# ***Interactive comment on “Hydrological control of large hurricane-induced lahars: evidences from rainfall, seismic and video monitoring” by Lucia Capra et al.***

Responses to V. Manville.

Fig. 1. Figure 5 from Vazquez et al 2016

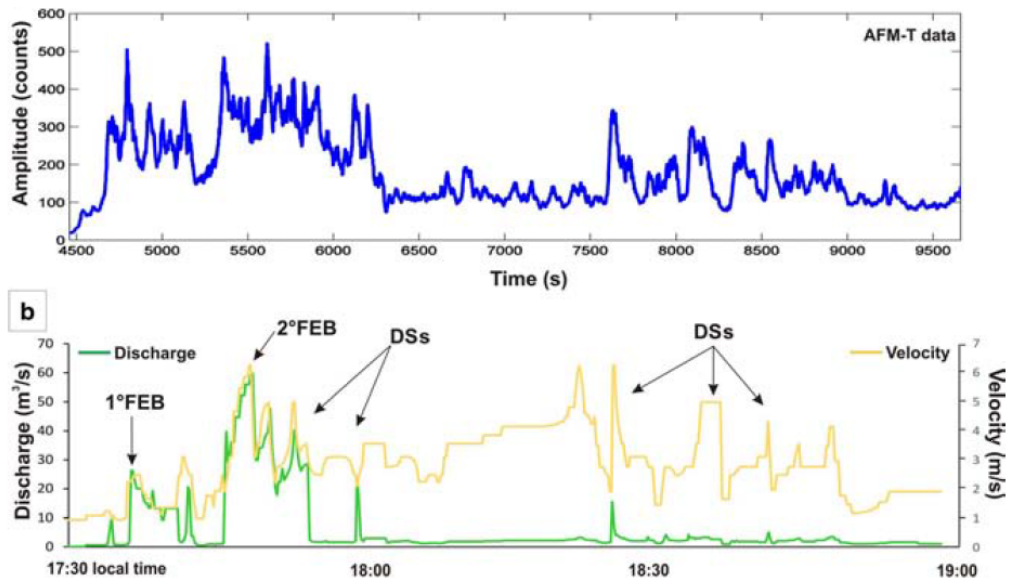
1(line 31). How do you define lahar size? By peak discharge, and if so where? Or by peak seismic amplitude by using this as a proxy for lahar volumetric discharge, even though the seismic energy output of a lahar is a function of many factors including volumetric discharge, sediment concentration and sediment grain-size distribution.

R1: Yes, we used the amplitude as a proxy for lahar volumetric discharge. On previous published works at Volcán de Colima (Vazquez et al., 2016), the size of lahars has been classified based on their seismic response (amplitude, validated with image data) and duration. With available images, the maximum peak discharge was calculated and assigned to the maximum amplitude recorded from the seismic station. We agree that it is not always possible to correlate the amplitude of the seismic signal with the flow depth, but based on real time data gathered at Colima, there is a quite good correlation for those large events (See. Fig. 5 Vazquez et al., 2016). The figure below extracted from Vazquez et al., 2016, clearly point to a correlation between lahar amplitude and flow discharge.

To better state this concept we slightly change the text at line # 183 as follow:

In particular, for lahars at Volcán de Colima a correlation between the maximum peaks in amplitude and the maximum peaks in flow discharge was found (Fig. 5 in Vázquez et al., 2016). Fluctuation in seismic energy along the vertical component reflects variation in flow discharge.

Fig. 2. Figure R2

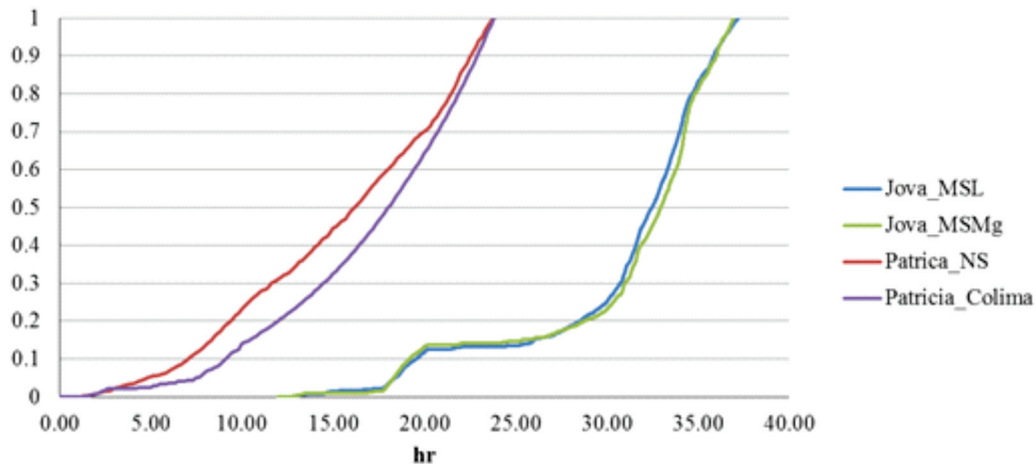
11 (line 335). This implies that there is no lag time between the peak rainfall intensity measured 6 km away on another volcanic edifice and the arrival of the lahar peak at the detectors.

R11: As observed for the Hurricane Jova, rainfall data from the station at Montegrande and La Lumbre ravine are almost identical (more than 8 km away). This means that the rainfall behavior is quite constant over a large area during a hurricane. Similar behavior is observed for Patricia event, by comparing the Nevado station with the raingauge at Ciudad de Colima. So even if data here used for the Hurricane Patricia are from a station located 6 km away from Volcan de Colima, we are considering that the rainfall intensity was quite homogeneous over these two volcanoes. The Figure R2 (see below) will be added as an extra panel to Fig. 3.
